Re: Petition No. 1401 - Revity Energy, LLC petition for a declaratory ruling, pursuant to Connecticut General Statutes §4-176 and §16-50k, for a 12.25-megawatt AC solar PV facility located at 424 Snake Meadow Road, Plainfield, Connecticut

Enclosed please find Revity Energy, LLC's responses to interrogatories in connection with the above-described petition.

Attachment CSC-1-9

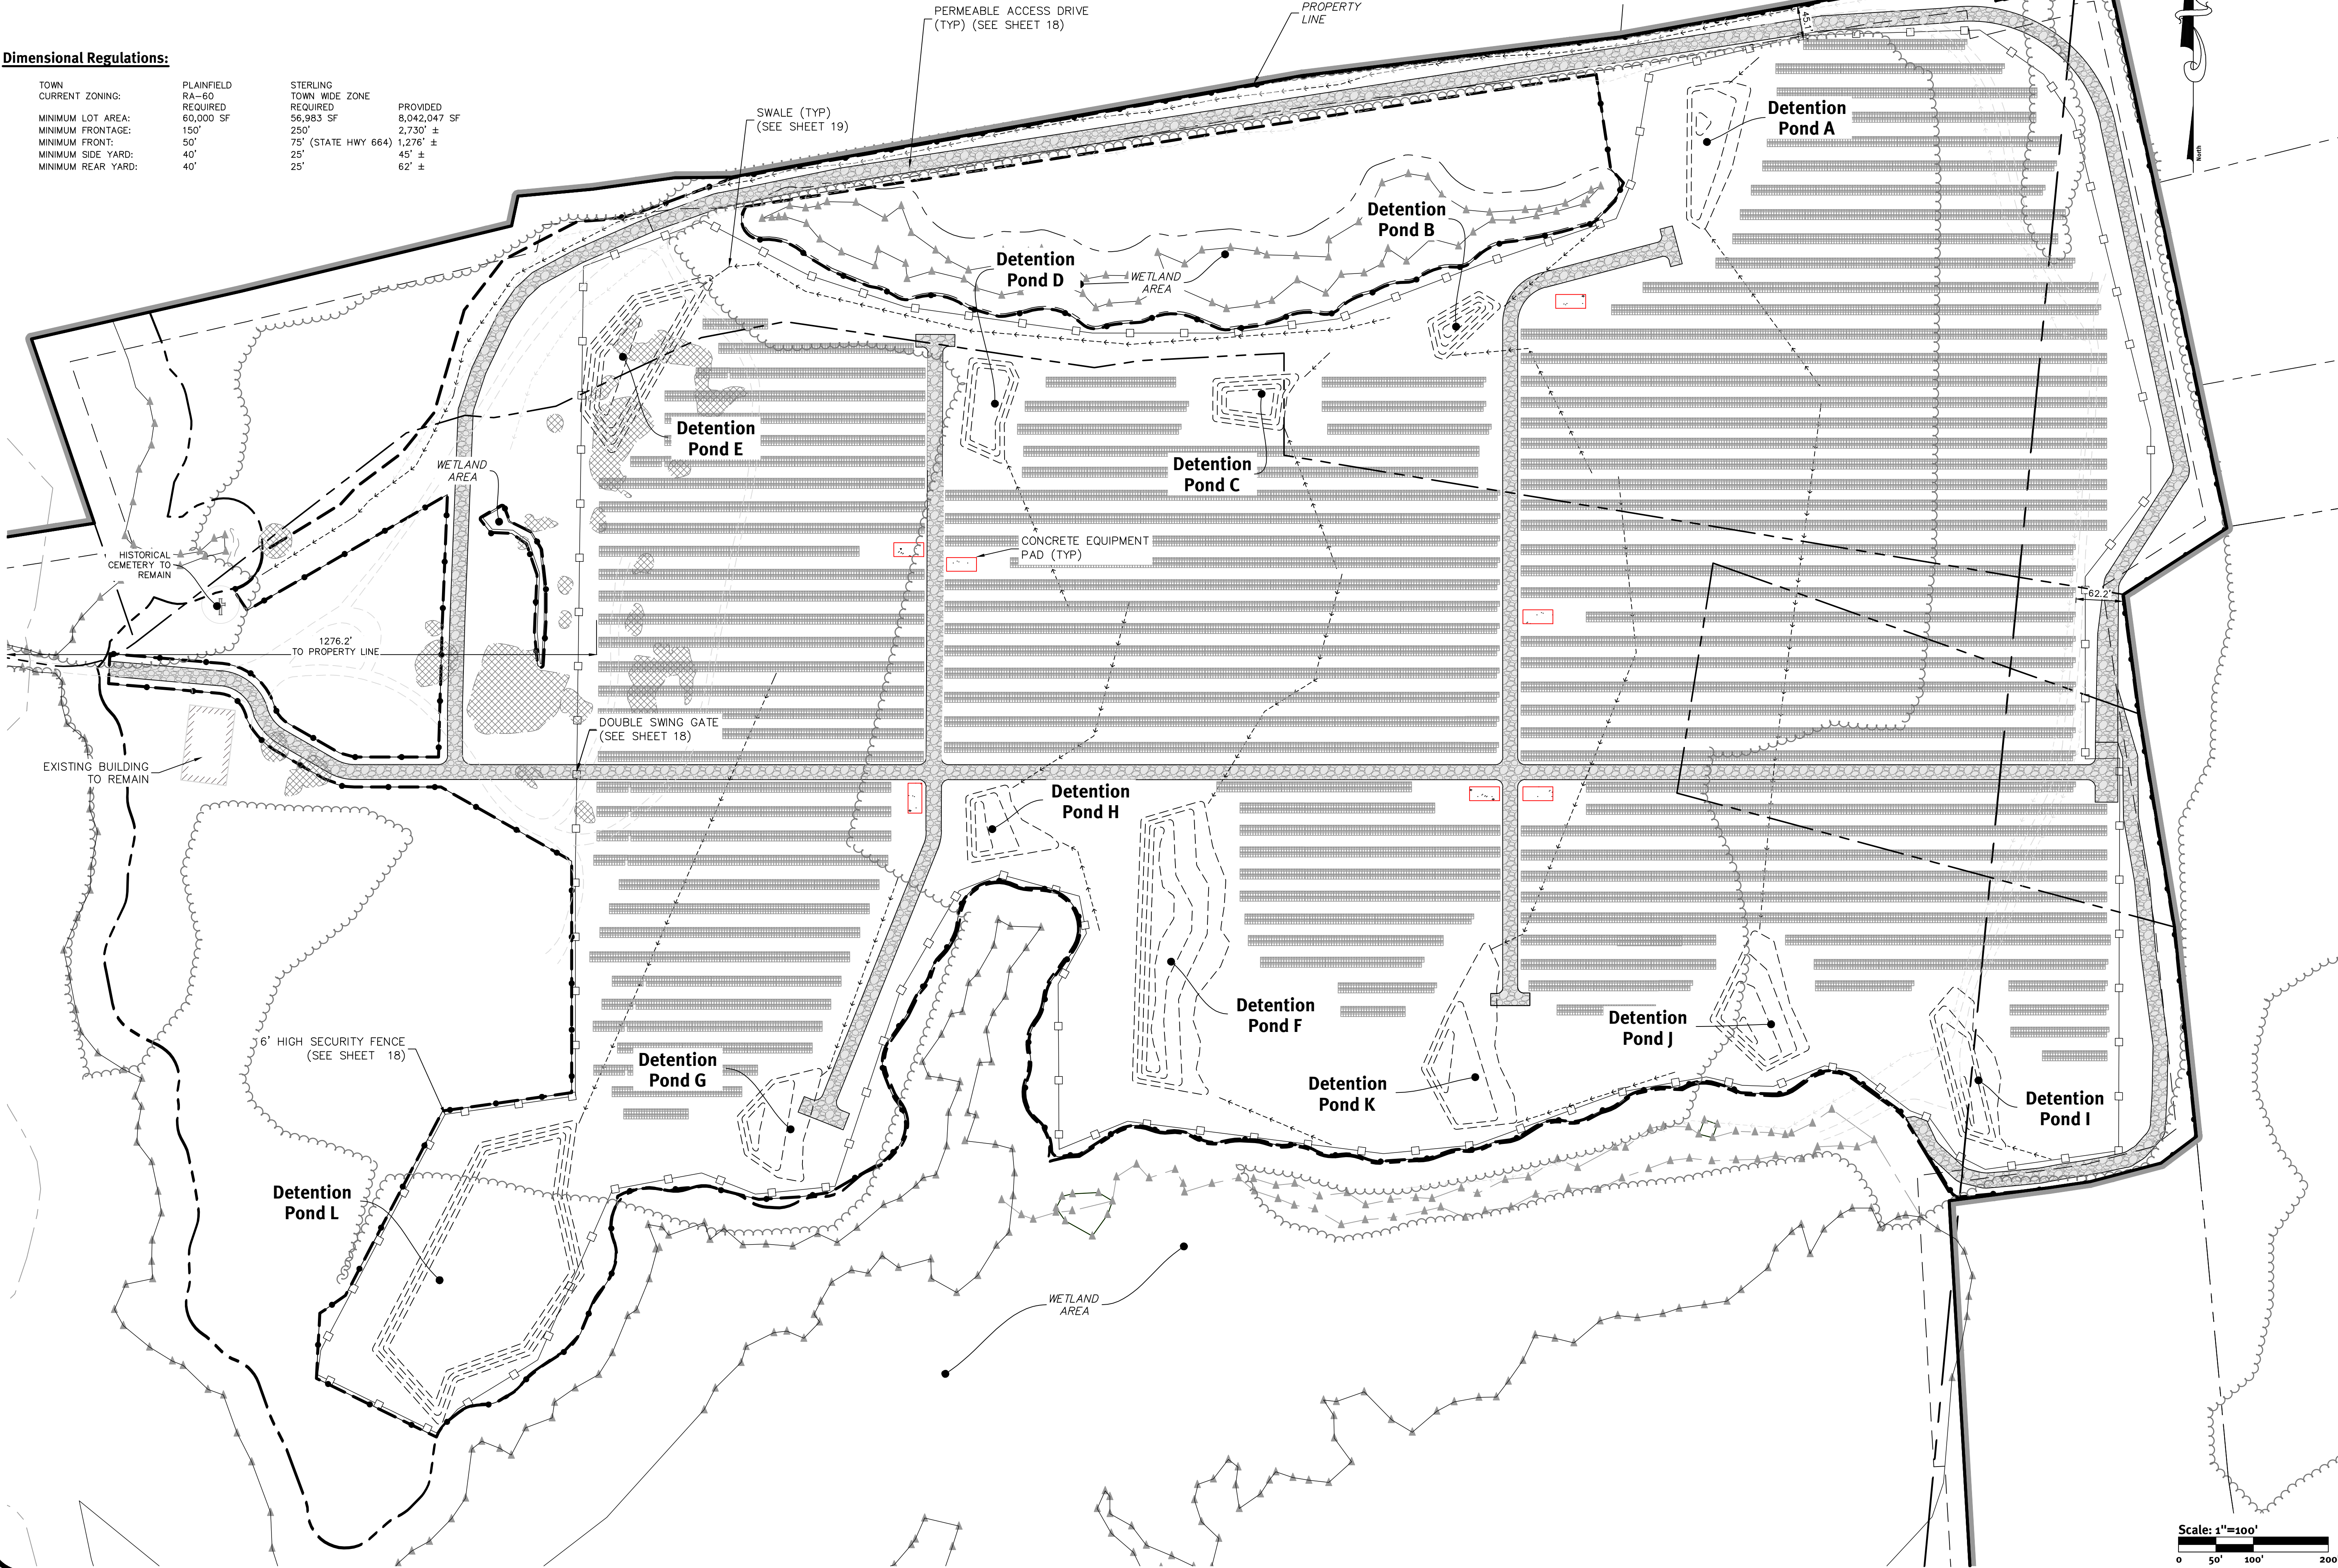
Q-CSC-1-9: Page 7 of the Petition states, "However, the Project will include seven equipment pads..." Sheet 6 of 19 depicts five "Concrete Equipment Pads." Where would the remaining two pads be located? If necessary, please update the required drawing(s).

A-CSC-1-9: The remaining two concrete equipment pads have been added to the site layout plan, which equipment pads are each shown as red rectangles on Attachment CSC-1-9.

Attachment CSC-1-29

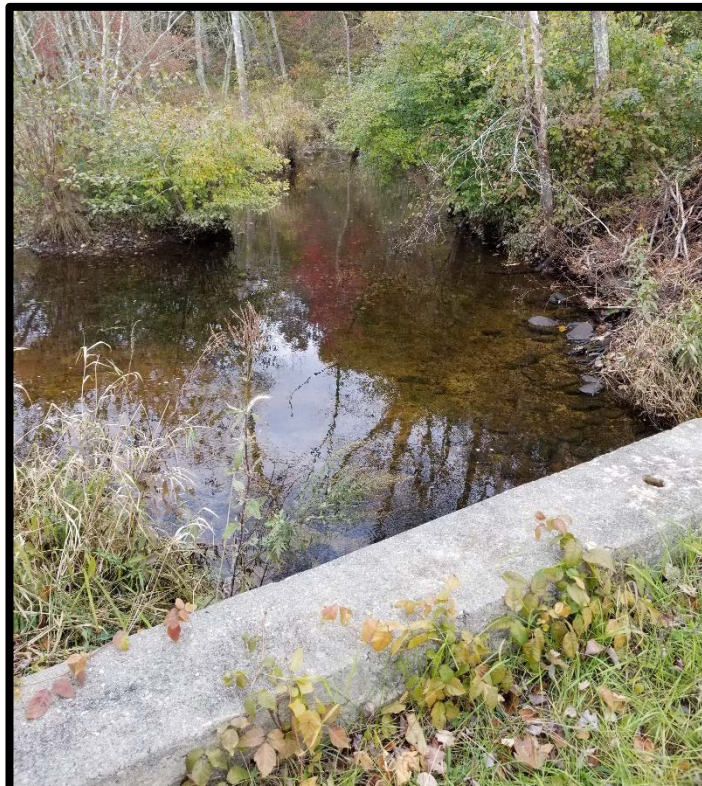
Q-CSC-1-29: Please submit photographic site documentation with notations linked to the site plans or a detailed aerial image that identify locations of site-specific and representative site features. The submission should include photographs of the site from public road(s) or publicly accessible area(s) as well as Site-specific locations depicting site features including, but not necessarily limited to, the following locations as applicable:

A-CSC-1-29: Please see Attachment CSC-1-29.
